DESCRIPTIVE REPORT

Registry No. H-11112

Sublocality Southeast Salisbury Sound and Sukoi Inlet

Project OPR-O112-RA-03

Figure 1. H11112 Survey Limits and Junction Surveys (chart 17324)

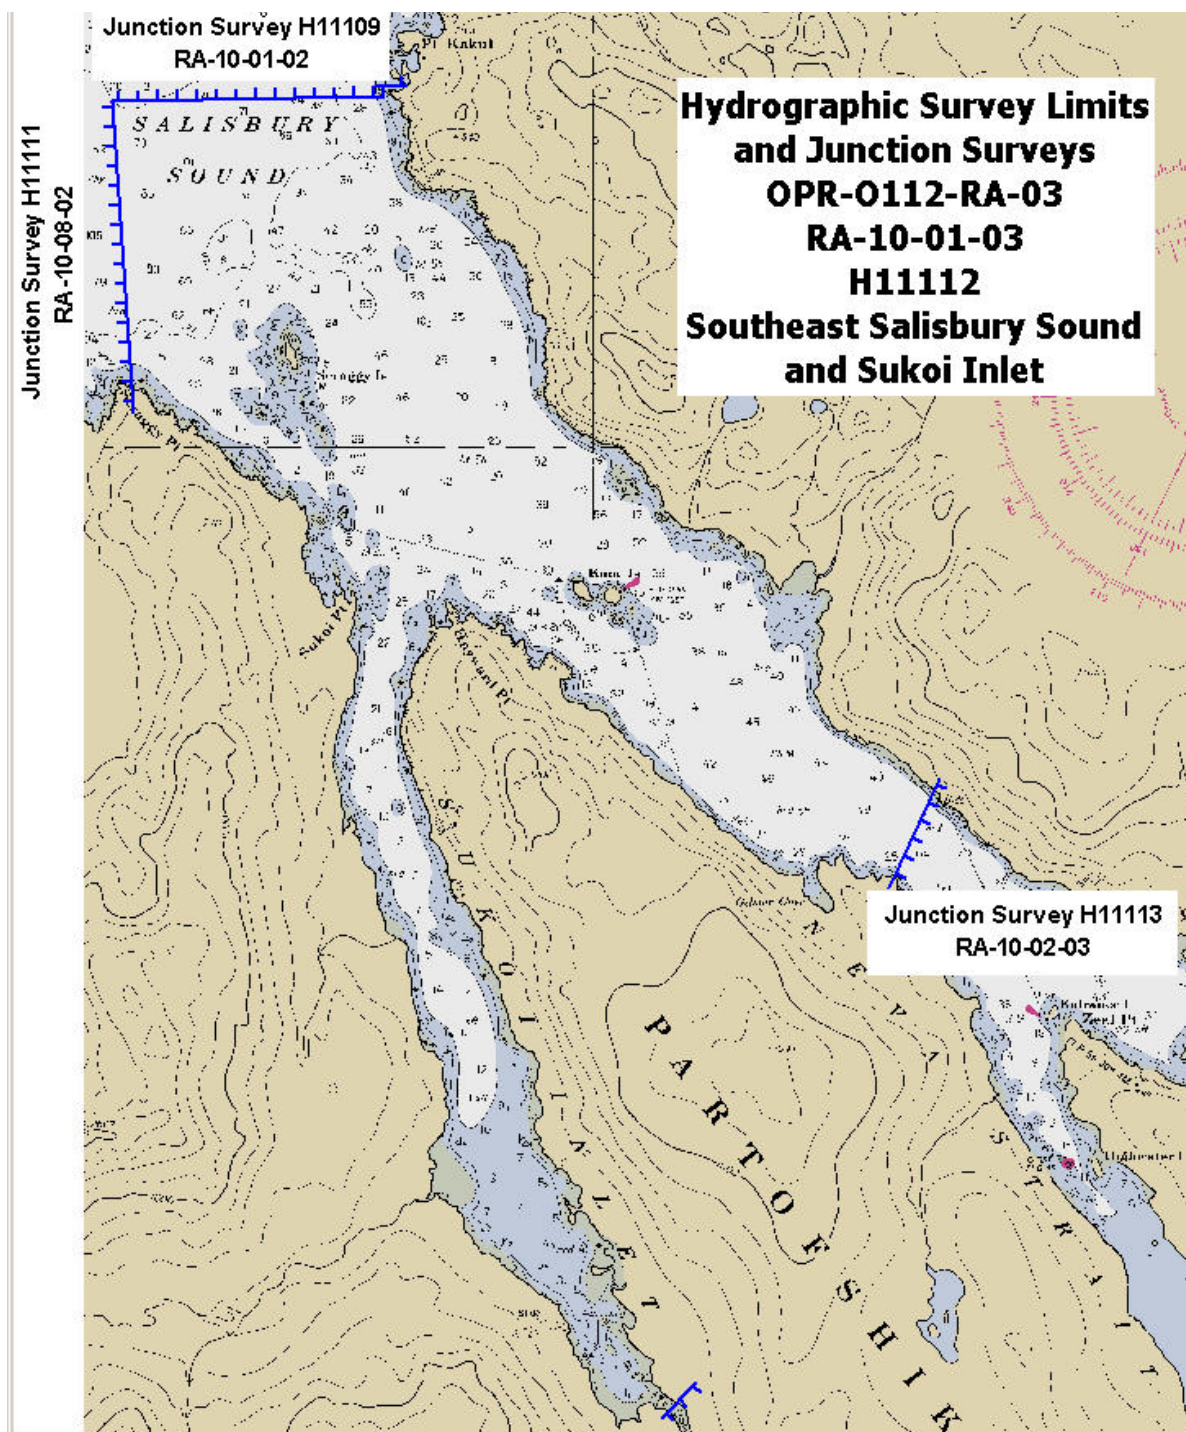
The following contemporary survey junctions with H11112 (see Figure 1):⁷

Survey H11109 junctions well with this survey. A cursory comparison indicates differences are generally less than two fathoms, many less than one fathom.⁸

Survey H11111 junctions well with this survey. A cursory comparison indicates differences are generally one to two fathoms.⁹

Survey H11113 junctions well with this survey. A cursory comparison indicates differences are generally less than one fathom.¹⁰

⁷ The junction with survey H11112, H11111 and H11113 are complete. A "Joins" note has been added to the smooth sheets where applicable. The junction with H11109 was not complete because the survey was processed earlier and sent to MCD. An "Adjoins" note has been added to the smooth sheet where applicable.
